Dam Safety Assessment of CCW Impoundments

Joppa Plant

United States Environmental Protection Agency
Washington, DC

September 24, 2010

AP-109 SH. 1

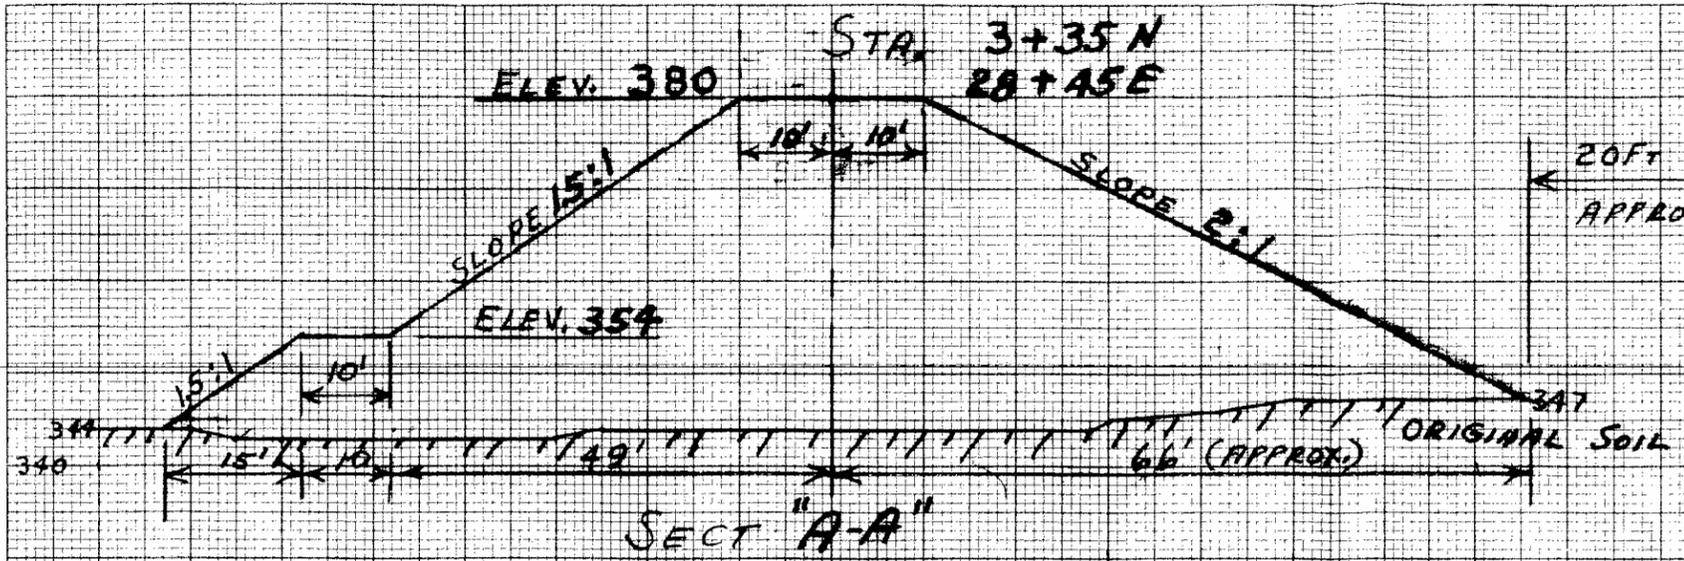
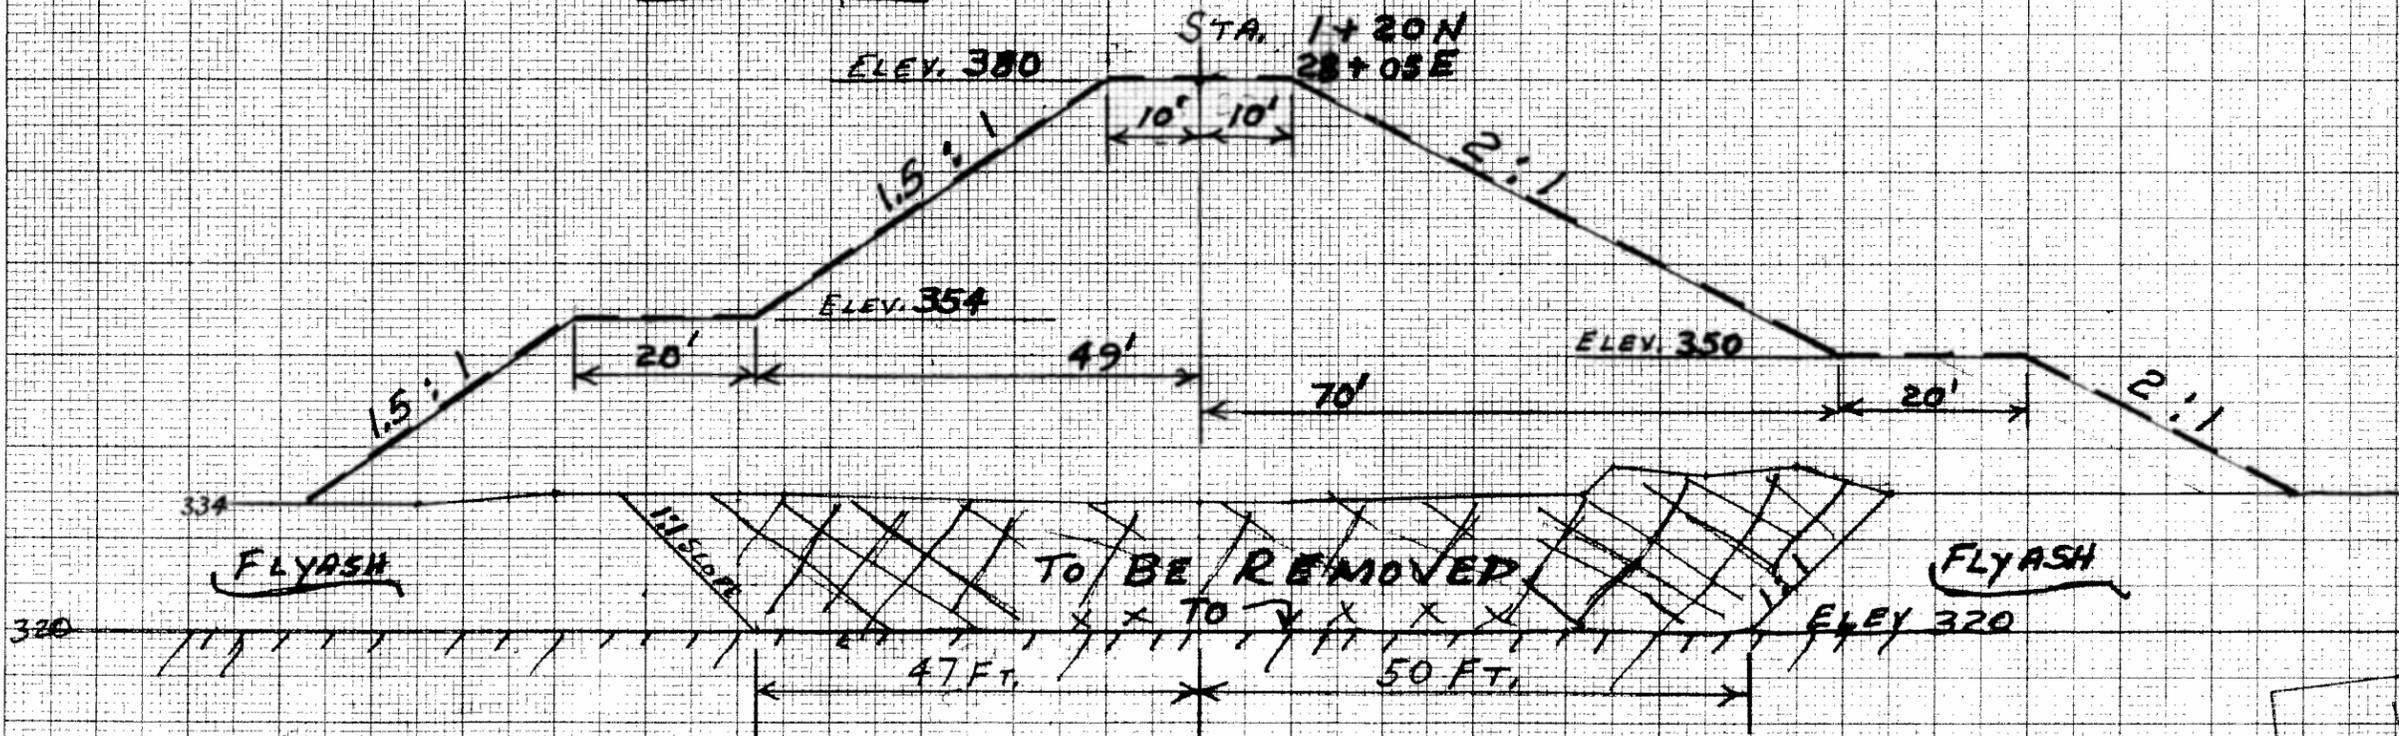
- The outboard slope is steeper than generally recommended for dam and dike construction. The design drawings (See attached EEI Drawing AP-109) indicate the slope should be 2H:1V, but the observed slope appeared to be steeper and matched the 1.5H:1V slope of the Northern Pond.

- Based on Drawing AP-109, Sht. 1 (attached), the Southern Pond embankment was keyed into a suitable foundation through a layer of fly ash for a portion of the embankment. Section A-A, which is indicative of construction in the area near the power lines (Dwg. 4229-8211, Sht. 1), indicates that this section of the embankment was not keyed into the underlying foundation.
